ADD-1 Report dated April 10, 2017 from the General Manager of Growth and Infrastructure regarding 1232252 Ontario Inc. – Application to amend a draft approved plan of subdivision, PIN 73580-0576, Lot 1, Concession 4, Township of McKim (Silver Hills Subdivision, Sudbury).

| Report Title |
|--|
| 1232252 Ontario Inc. - Application to amend a draft approved plan of subdivision, PIN 73580-0576, Lot 1, Concession 4, Township of McKim (Silver Hills Subdivision, Sudbury) |

**RE: Application for Re-drafting of a Draft Approved Plan of Subdivision –
1232252 Ontario Inc. – PIN 73580-0576, Lot 1, Concession 4, Township of
McKim (Silver Hills Subdivision, Sudbury)**

PROPOSED AMENDED DRAFT
APPROVED PLAN OF SUBDIVISION

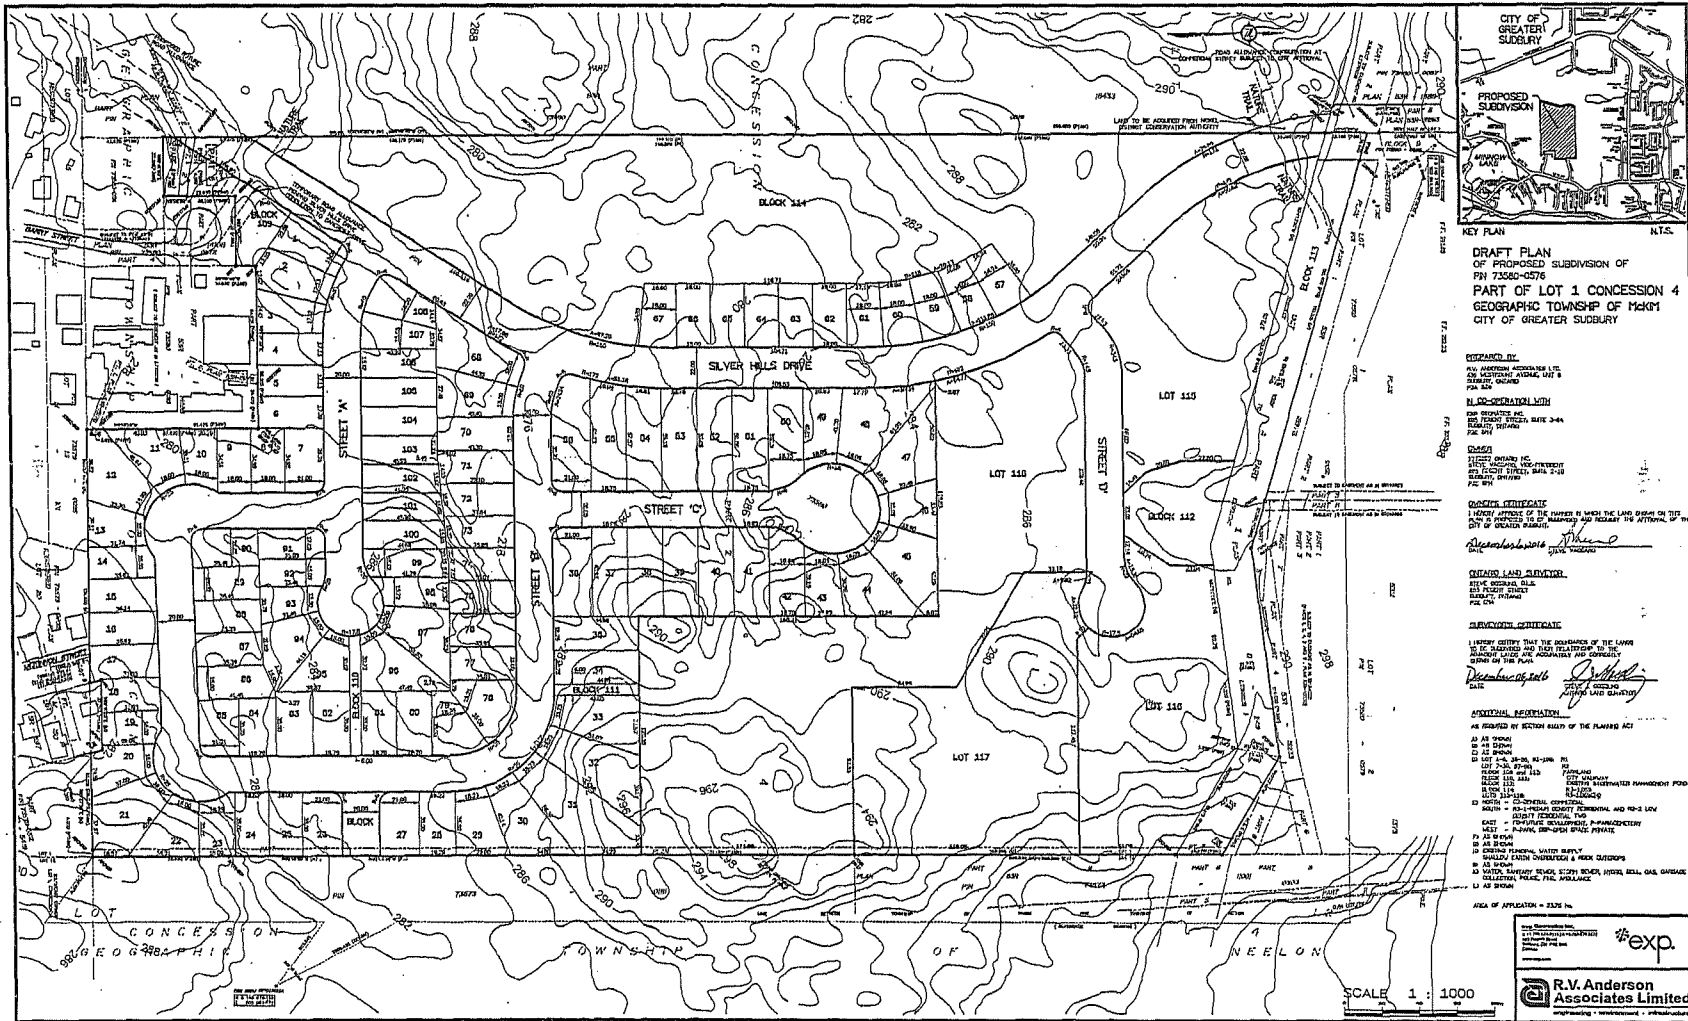
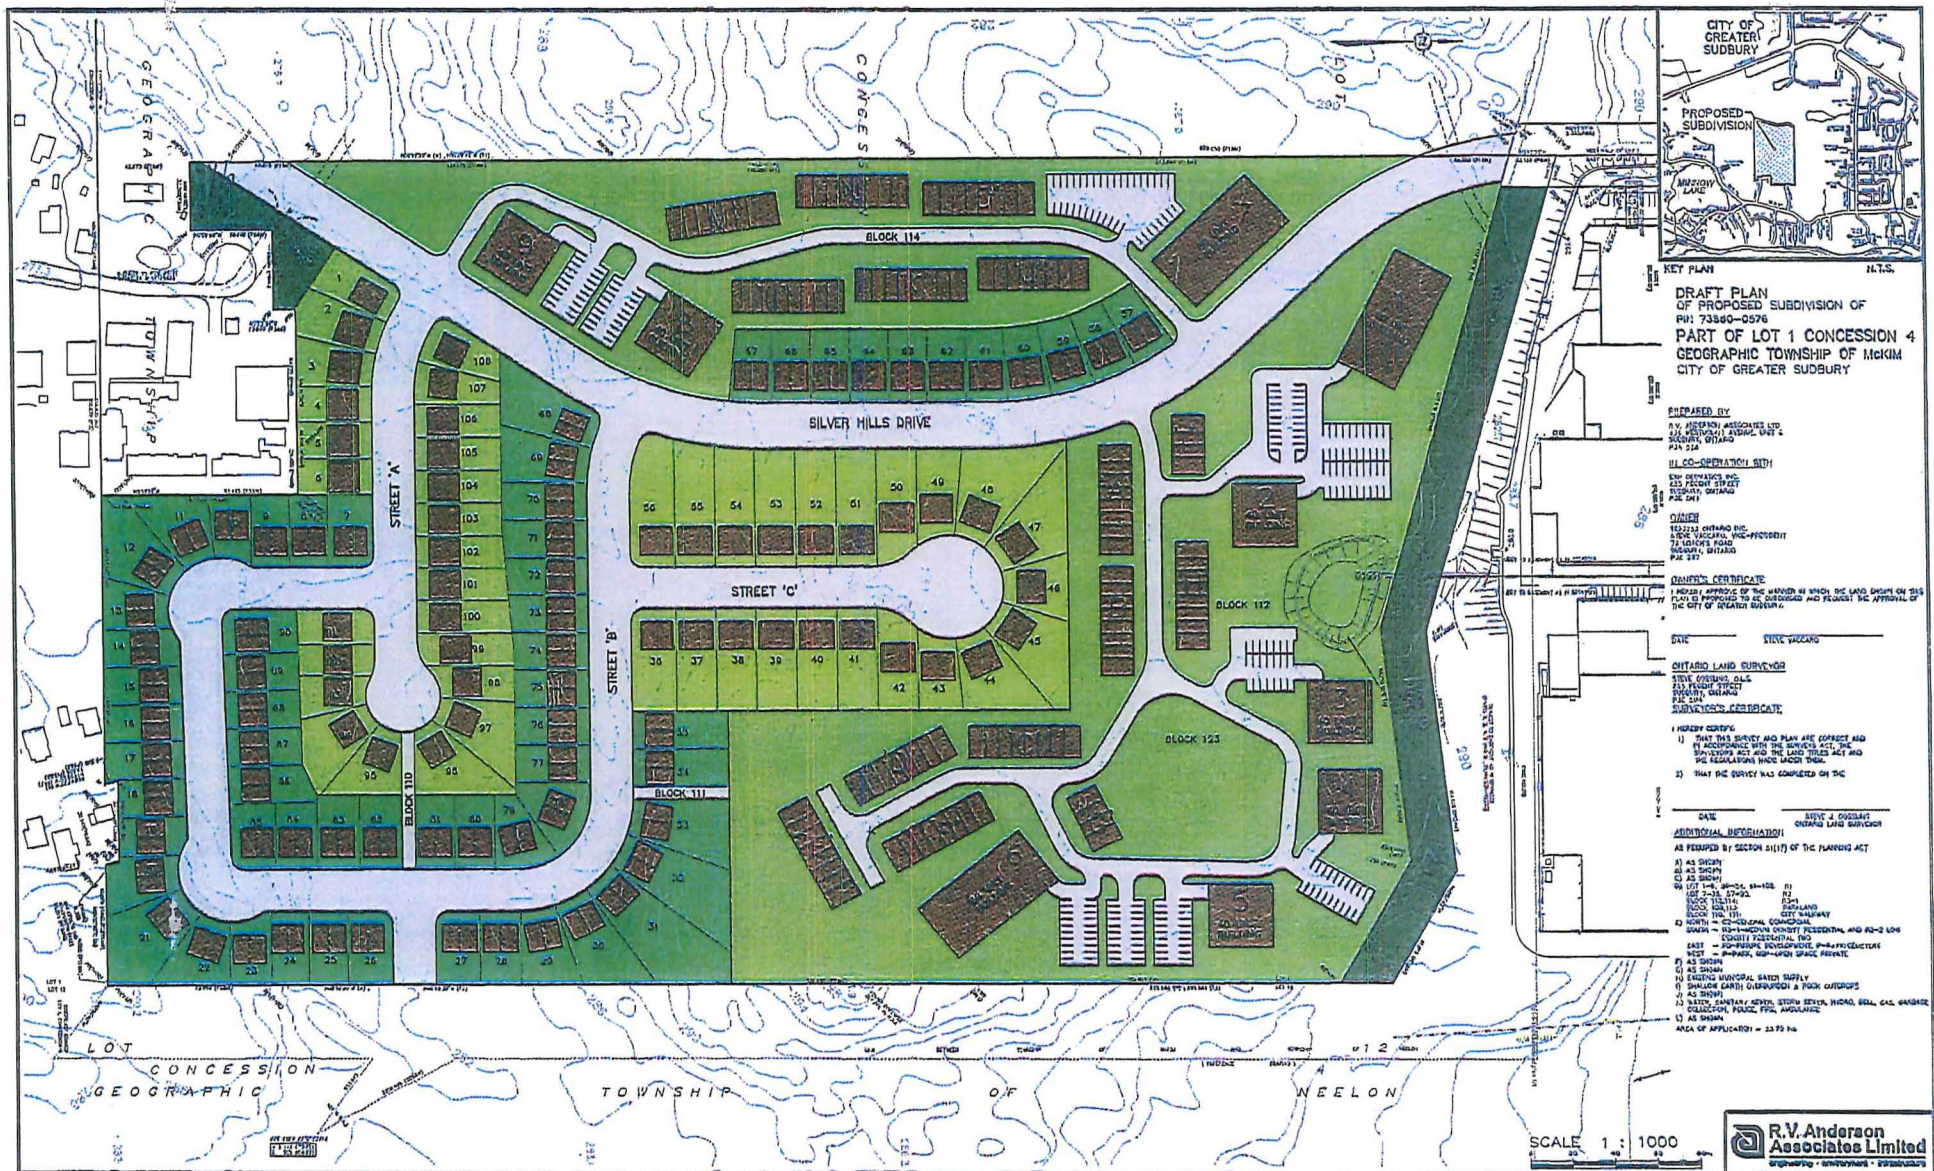
Staff would finally also note for the information of the owner that the proposed revised plan continues to depict a 22 m (72.18 ft) right-of-way along Silver Hills Drive whereas Condition #18 requires a width of said right-of-way of 23 m (75.46 ft).

We note that there is a new road on the supplied drawing identified as Street D. We will require a connection between Street D and Street C, so that no cul-de-sacs are created.

Provide a continuous sidewalk on the east and north side of Streets C and D to enable safe access for pedestrians and transit users between Silver Hills Drive and the future development.

Provide a direct sidewalk connection from Lot 118 to Silver Hills Drive.

With the addition of the new cul-de-sac, Street 'D' in proximity to the proposed cul-de-sac, Street 'C', and the proposed usage on Street 'D' as a senior's care facility, it may be prudent during the design phase of the subdivision for the owner to consider looping the watermain between these culs-de-sac. This would act to ensure supply of water in the case of any break that may occur in the main on Street 'D'.

2. That the reference in Condition to #1b. to "Block 112" be deleted and replaced with "Lot 118";
3. That the reference in Condition #1c. to "Block 112" be deleted and replaced with "Lot 115";
4. That Condition #1d. be amended to insert after "separate block" the following "for storm water management purposes and";
5. That Condition #15 be amended to insert after "maximum of 30 single" the following "or-semi-detached".
6. That a new Condition #1e. be added as follows:

"1e. That the plan be revised to include a pedestrian walkway block to be transferred to the City, extending from "Street C" to Lot 118 in a location and configuration to the satisfaction of the Director of Planning Services."
